STAFF RECOMMENDATION

921 Benton Avenue

May 15, 2019

Application: New Construction – Addition and Outbuilding

Figure 6: Alley-facing elevation of the garage.

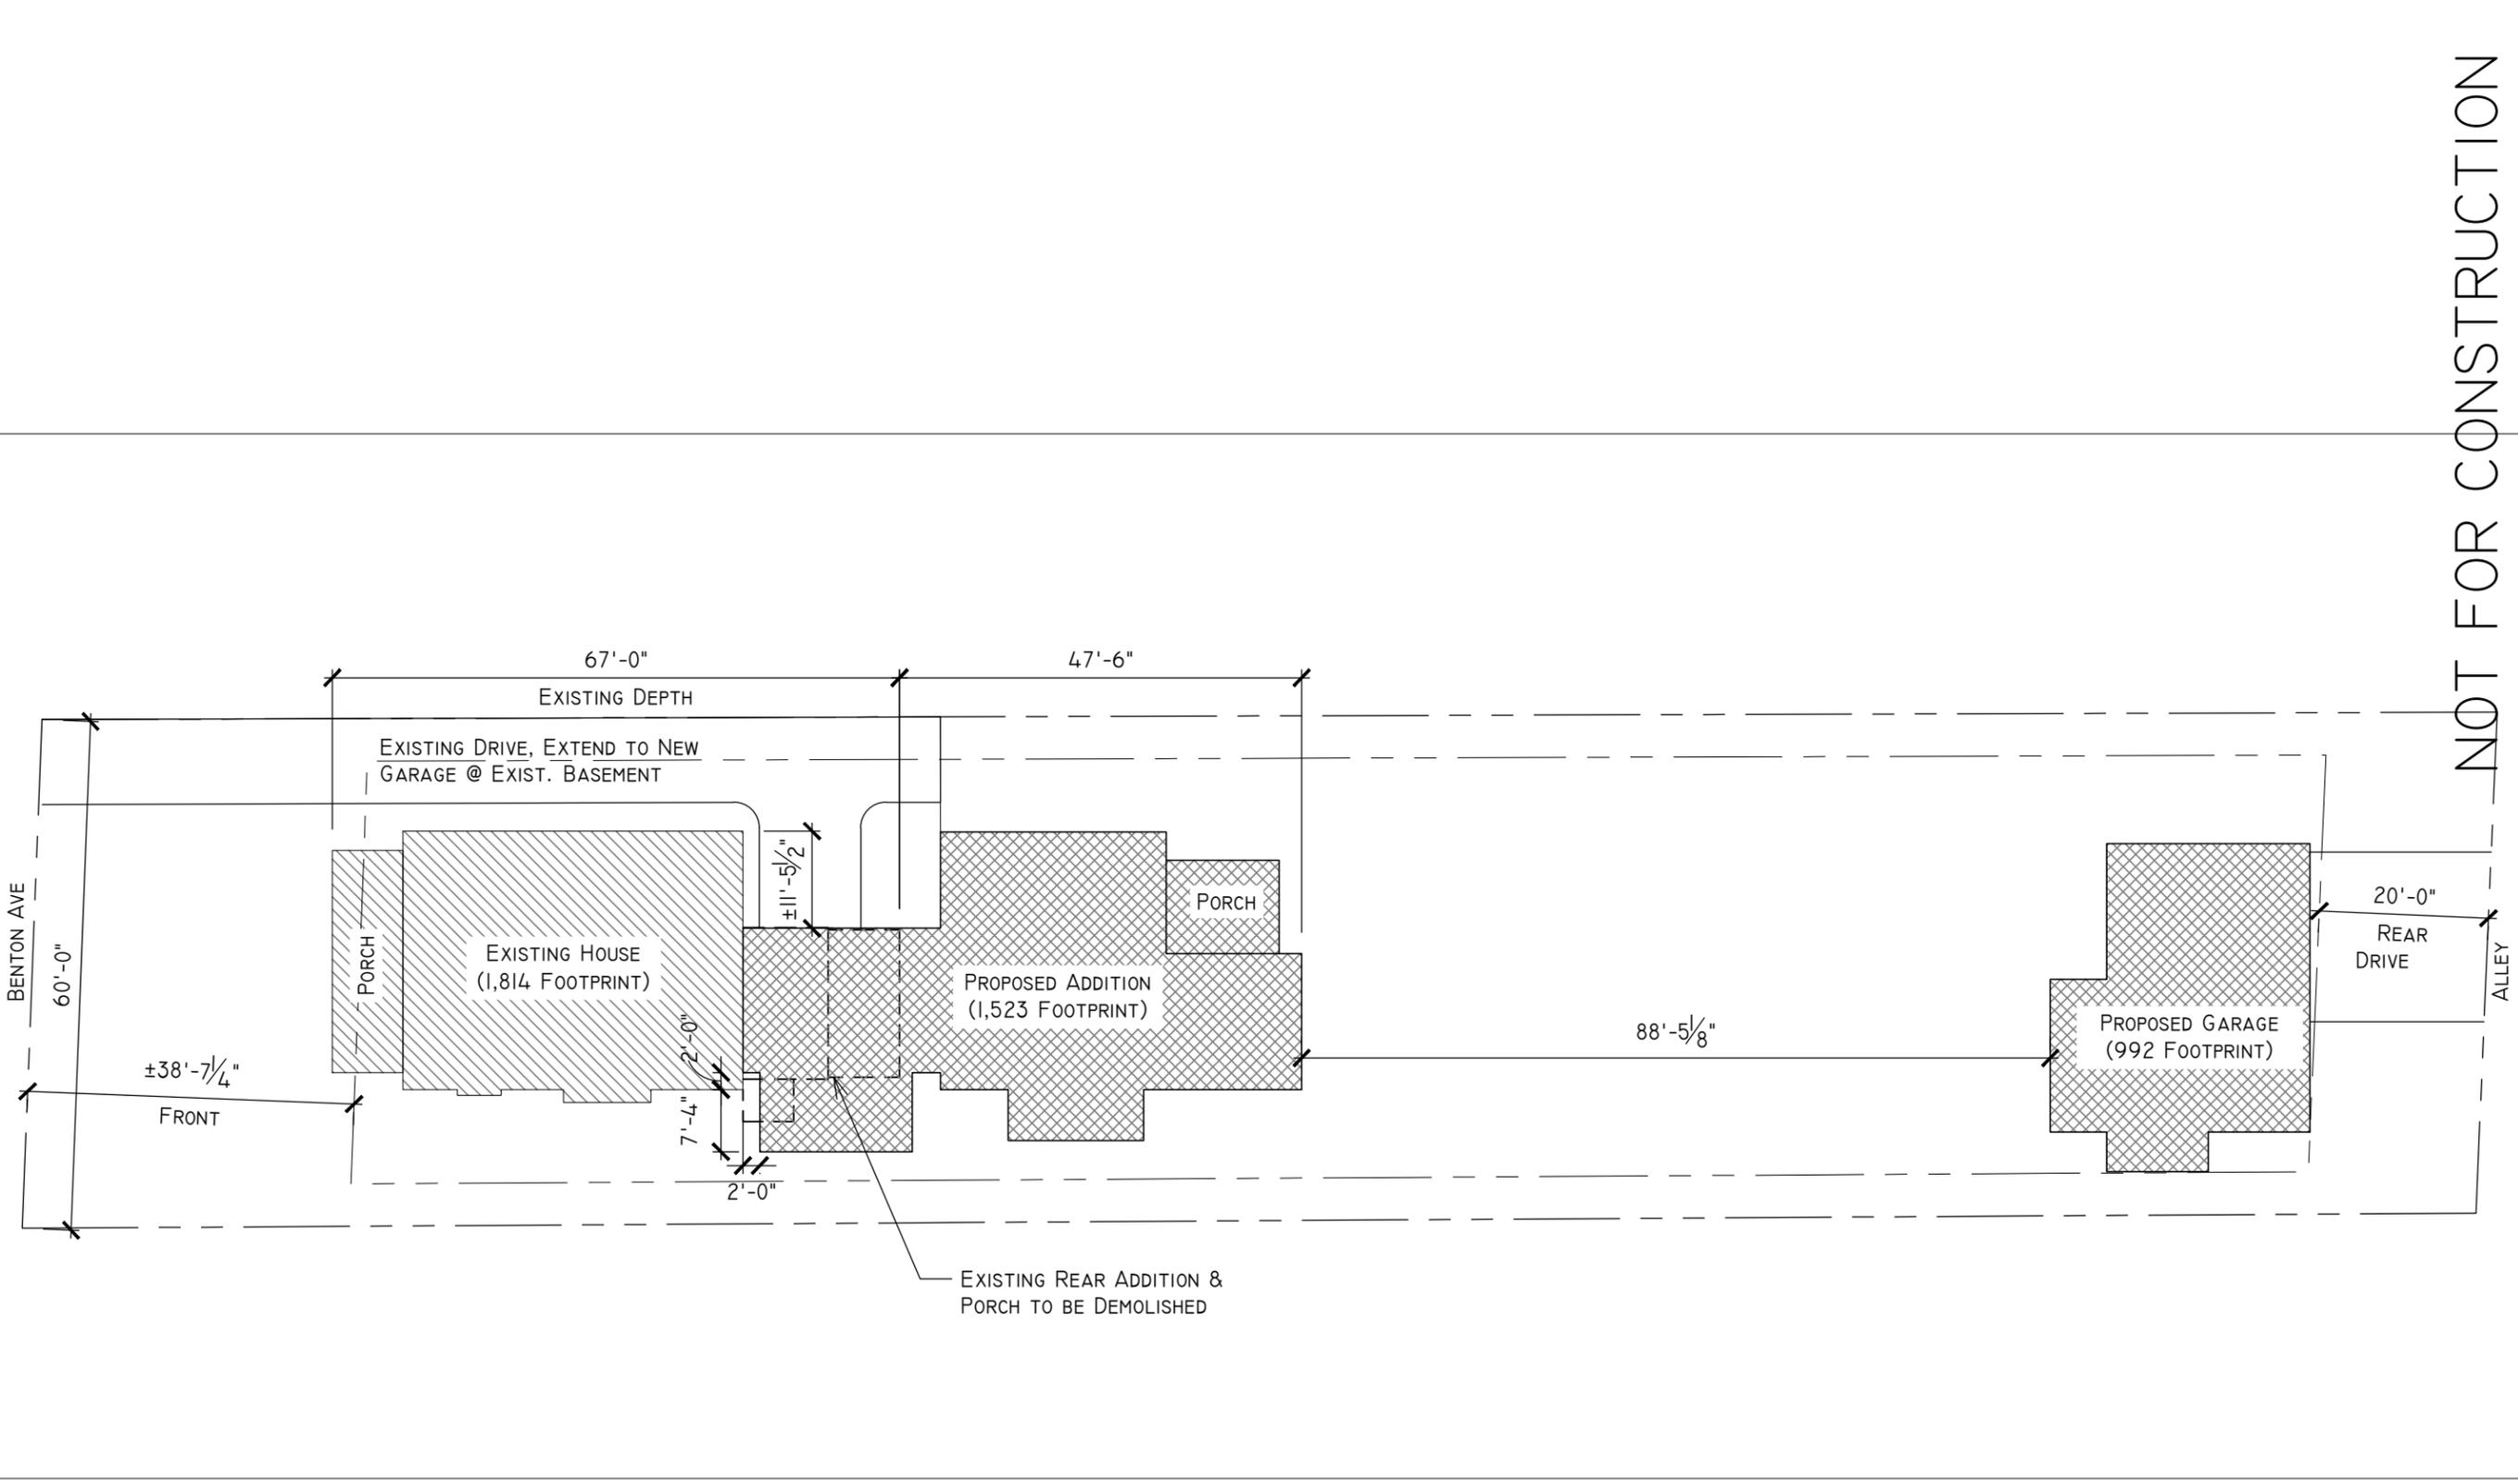
The roof and eave heights of the proposed garage meet the requirements of the design guidelines. The proposed square footage of the outbuilding is nine-hundred-ninety-two (992) square feet and the lot is approximately seventeen thousand, two-hundred-eighty (17,280) square feet. The guidelines allow outbuildings to be up to one-thousand (1,000) square feet on lots over ten-thousand (10,000) square feet. Staff finds the height and scale of the proposed outbuilding meets section III.H.1.a & b of the design guidelines.

Design Standards: The materials, proportions, and overall character of the outbuilding will be similar to the house. Its gabled roof form will match that of the house, and the materials will not contrast greatly with the primary structure. The window proportions and locations are compatible with those of outbuildings historically. Staff finds the design of the proposed outbuilding to meet section III.H.2 and 4 of the design guidelines

The north and south elevations of the outbuilding include dormers. These are both eighteen feet (18') wide on a thirty-seven foot (37') roof. The dormers are set in two feet (2') from the wall below. The roof of the building meets section III.H.3 of the design guidelines.
